S E R V I C E B U L L E T I N N o . 2 3

Affected Aircraft: DIMONA H-36

Subject: Modification to the original austrian version

Reason: Type approval for Italy

Druck 11
Leakage Protection
Vot

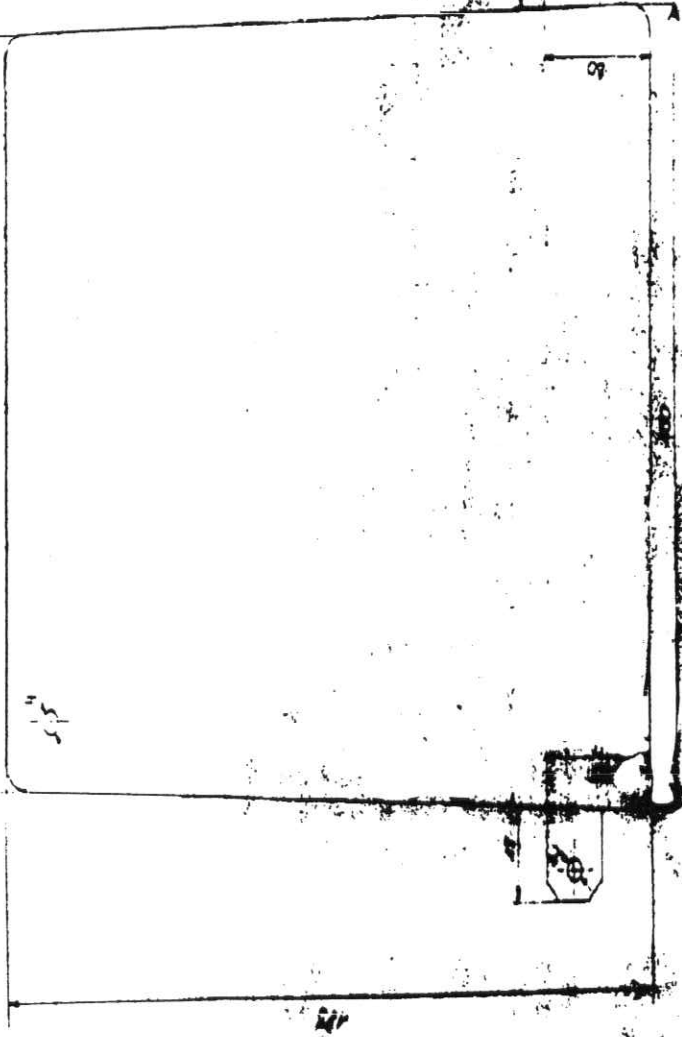
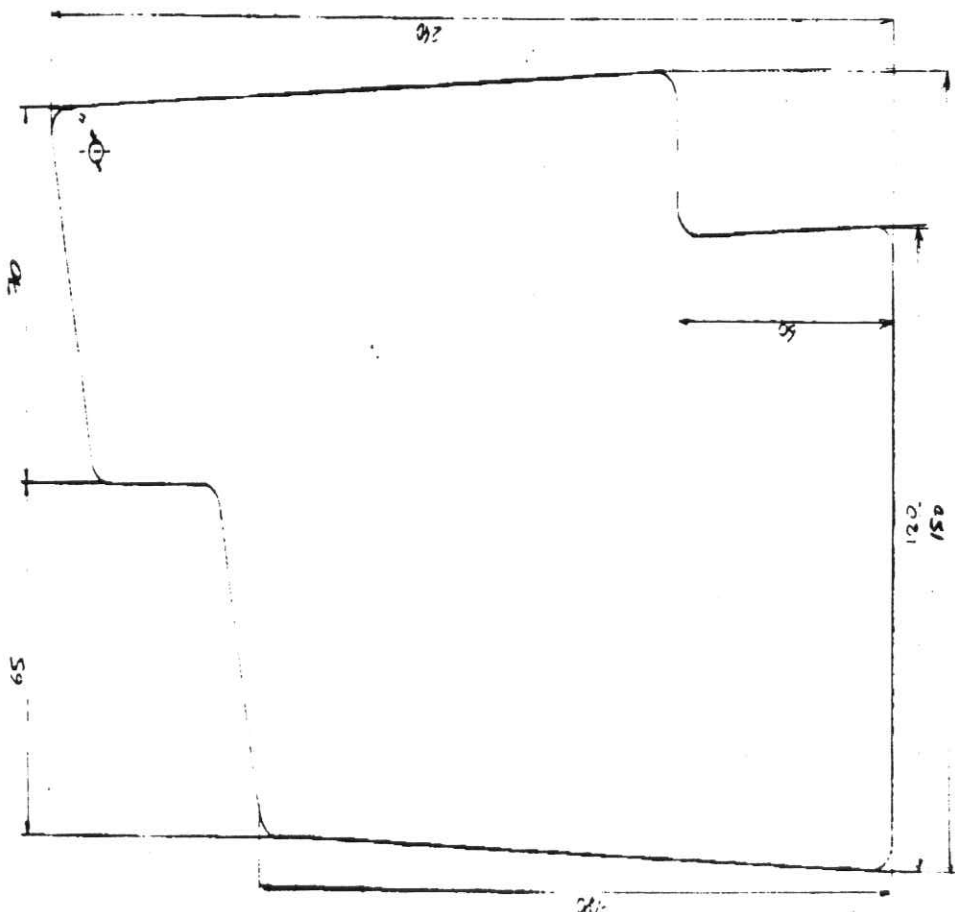
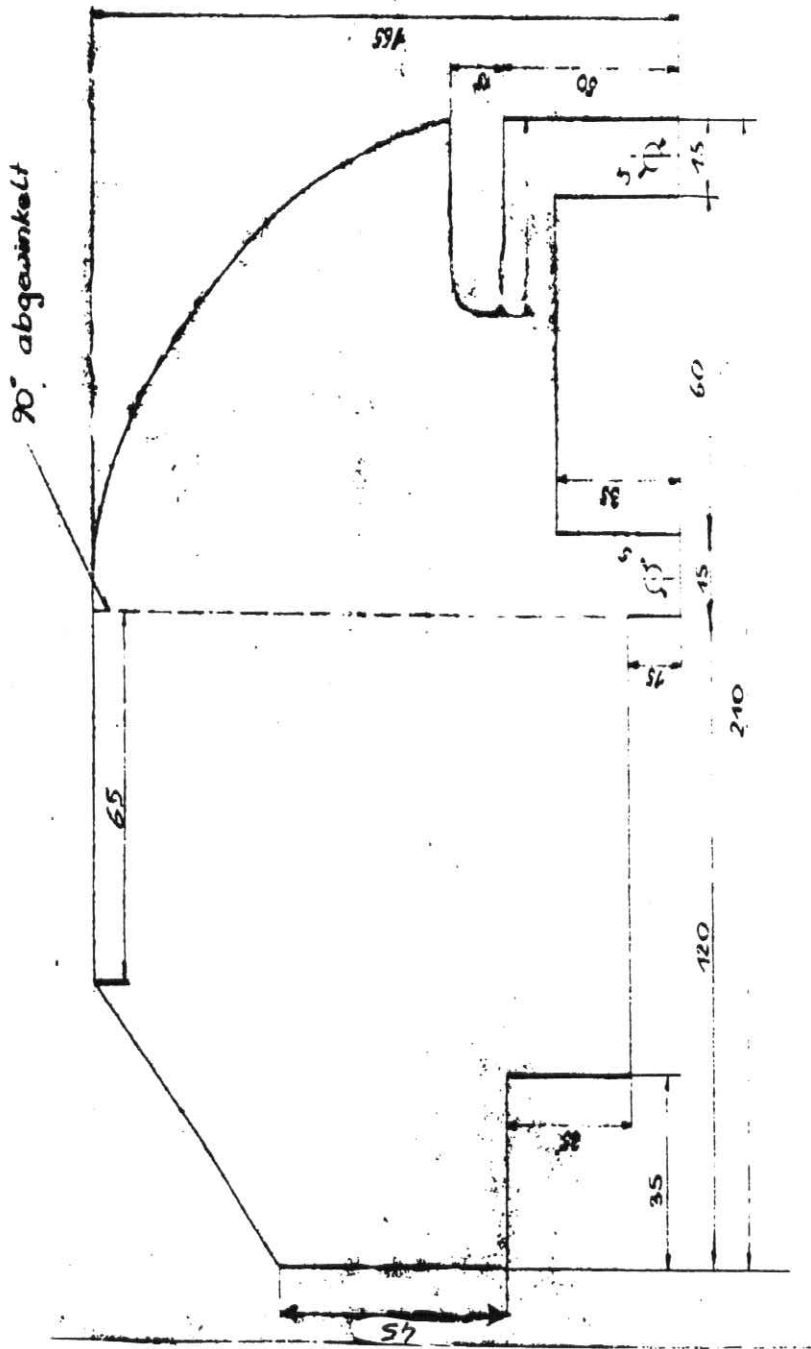
5. The provision for protection against fuel leakage on manifold joints near carburetor and better segregation of DC regulator, electrical system and fuel system shall be provided. See attached drawings.
